From: John Stalder <john@e-corp4u.com>
Sent: Thursday, March 24, 2022 11:17 AM
To: Steve Peterson <stevep@clhae.com>
Cc: Russ Tonks <russ@e-corp4u.com>; Osman Uygun <osman@e-corp4u.com>
Subject: Reconfigure M1 Room ARTCC Project RFI #1

Reconfigure M1 Room ARTCC: Access Flooring

1		RFI 01	3/31/22
REV	APPROVED DATE	DESCRIPTION	JCN REDLINE DATE APVD
DEPARTMENT OF TRANSPORTATION FEDERAL AVIATION ADMINISTRATION ATO - TECHNICAL OPERATIONS WESTERN SERVICE AREA			
ARTCC RECONFIGURE M1 ROOM MAIN FLOOR PLAN			
PALMDALE		LOS ANGELES CTR	
REVIEWED BY	SUBMITTED BY	APPROVED BY	
ART GAPASIN PROJECT ENGINEER		DARYL KITCHEN MGR. ENGINEERING - LA	
DESIGNED	ISSUED BY	DATE	JCN
KDL	ENGINEERING SERVICES	02.04.2021	1004394
DRAWN	ENROUTE/FSS	DRAWING NO	REV
KDL		ZLA-D-ARTCC- A101	
CHECKED	SJP

C8 MAIN FLOOR PLAN
1/8" = 1'-0"
0 4' 8' 16'

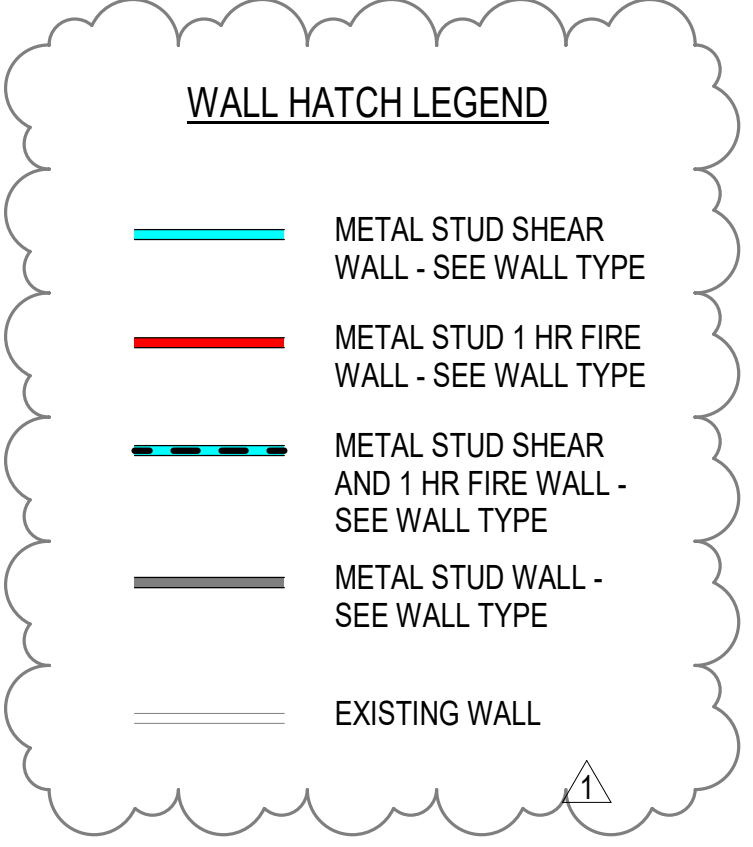
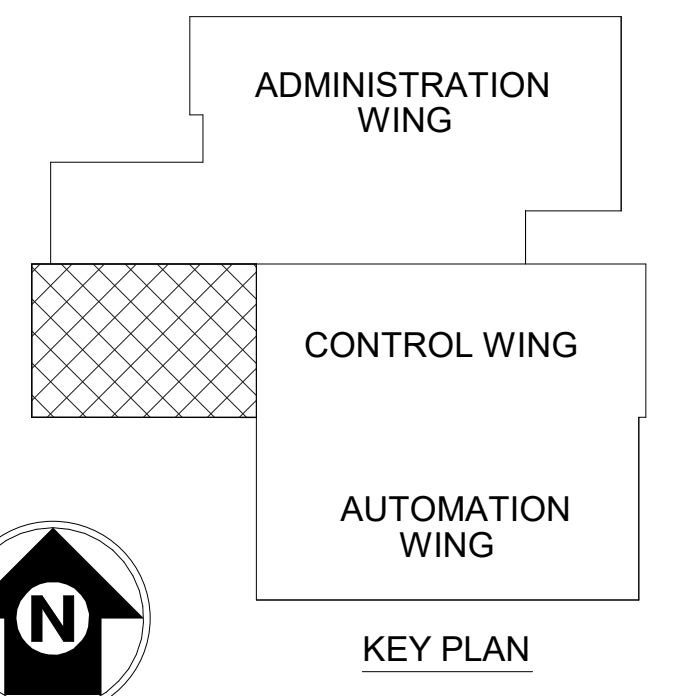
1. On sheet A1.1 I don't see wall types called out for the offices on the right side of the plan. Are these all type A? Break room walls show type B & D but the other two walls are not called out. **See attached revised A1.1.**
2. Some of the walls are colored RED and some Light BLUE. What is this to indicate?
See attached revised A1.1, wall hatch legend

C8 MAIN FLOOR FINISH PLAN
 1/8" = 1'-0"
 0 4' 8' 16'

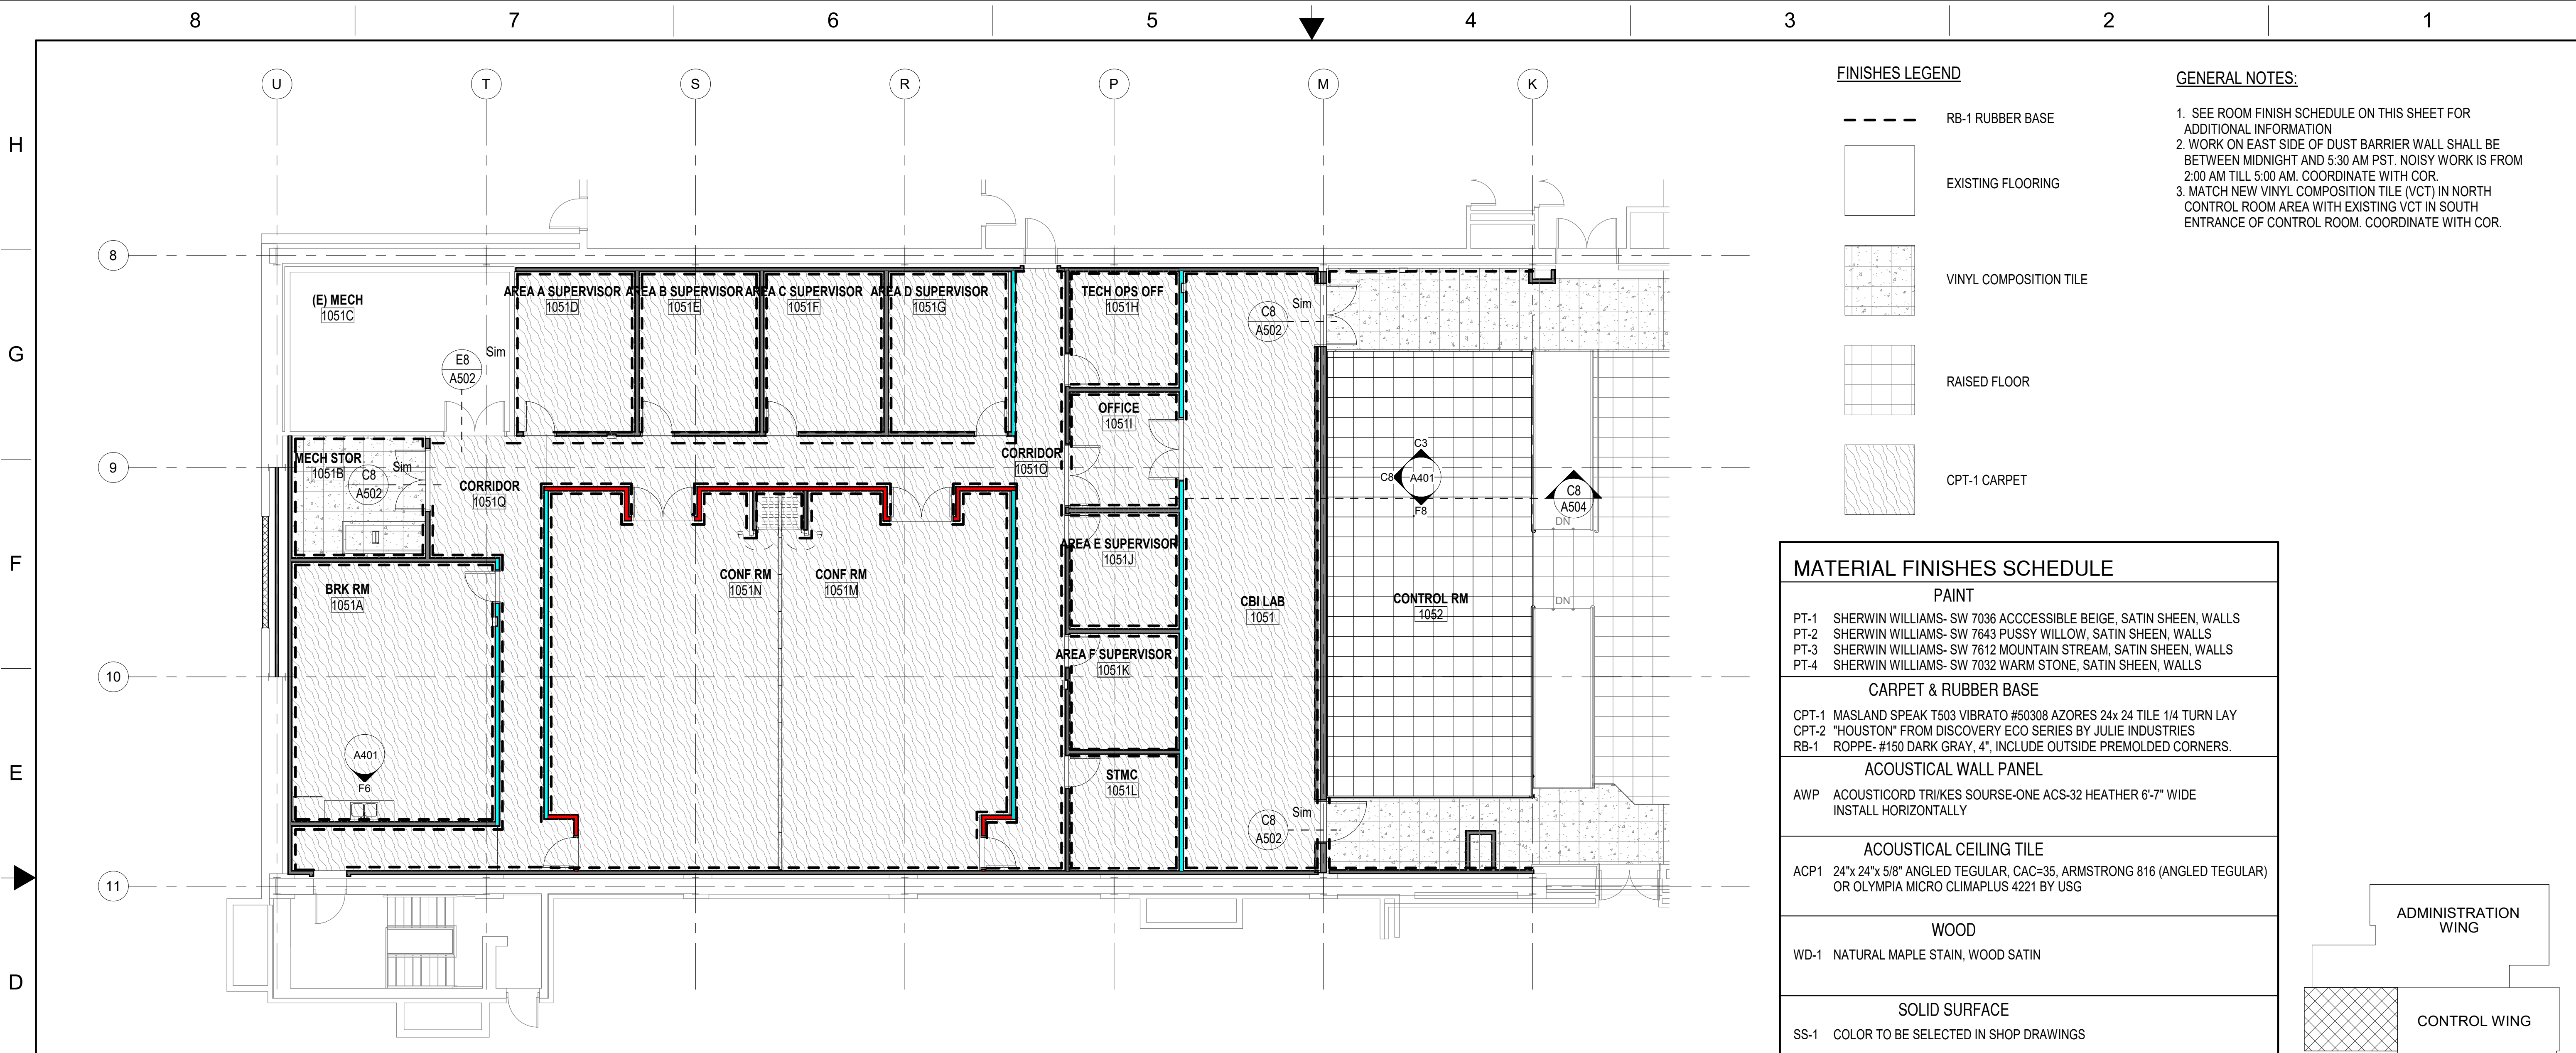
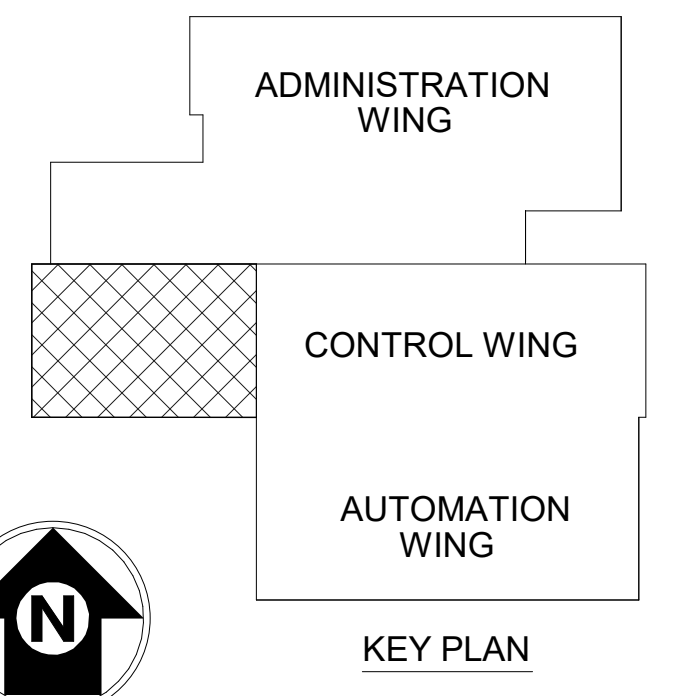
4. The Finish Schedule on Sheet A102 calls out for both CPT-1 and VCT-1 in the Control Rm, but we could only locate the location for the carpet tile. Please advise where the VCT-1 goes and confirm both it and the carpet tile will be field-applied by others.

5. The finish schedule calls for CPT0-1 in the mechanical storage room (1051B) but the floor plan shows Vinyl Composition Tile. Which is correct?
VCT is correct see revised A102
6. Control RM 1052 shows vinyl composition tile on each side of the access flooring. Is this flooring to be new? If so, where does it stop?
Yes on the flooring is new, we think grid K, unable to access this area. E-Corp researching .

Carpet is shown on raised flooring, and VCT is shown on the concrete floor to both sides. Carpet and VCT installation is means and methods?

C8 DOOR AND FRAME TYPES
1/4" = 1'-0"

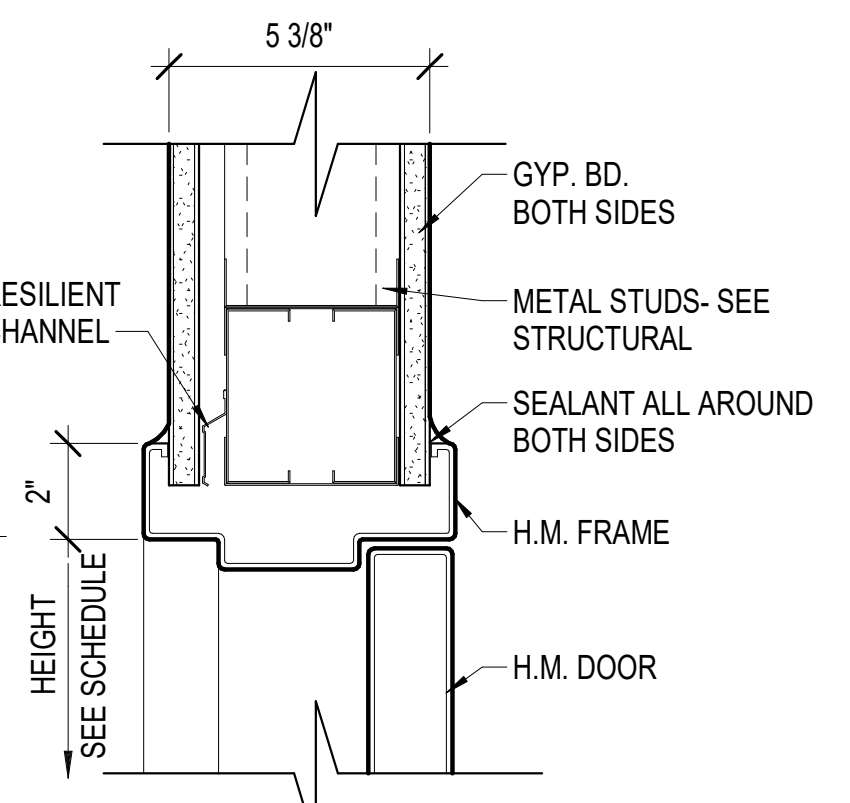
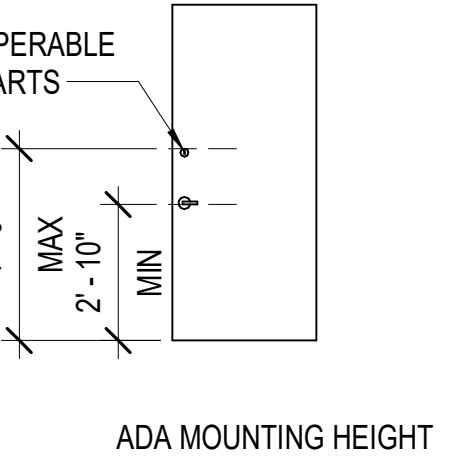
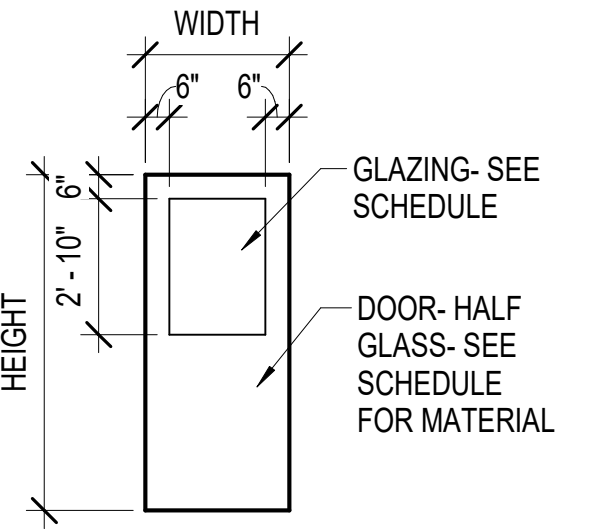
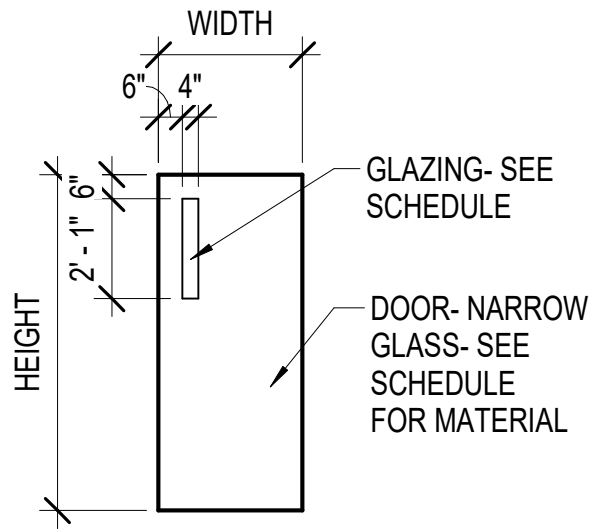
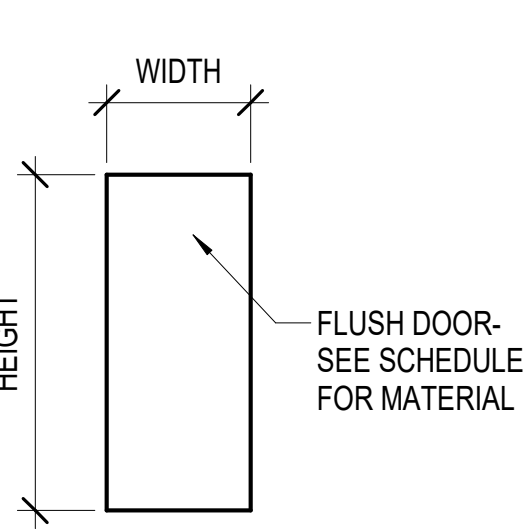
1. The door schedule indicates the hardware groups are in the spec. we cannot find hardware groups in the spec nor does the door schedule list the hardware group for each door. Can you provide this information. – **See revised A601 and Spec 08710.**
